Access Compliance Report

(Curb Ramps)

| Intersection ID: 16626 | Main Street: INDEPENDENCE_WOODS_DR | Cross Street: HOOPER_CT | Location: NE |
| ADA ID: 7DF906EF66AD | Ramp Type: PerpDiag | Initial Pass/Fail: Fail | Overall Compliance: No |

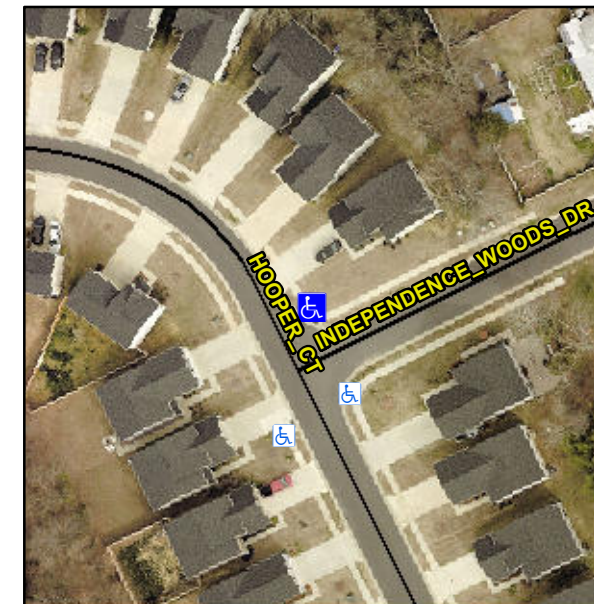
Not Found, R304.2.2

| Compliance | Description | Data | Compliance | Description | Data |
|------------|-----------------------|------|------------|-----------------------------|------|
| N/A | Ramp Length (in) | 53.0 | No | Ramp Slope (%) | 11.2 |

Remove & Replace Curb Ramp With Two New Directional Ramps or Equivalent.
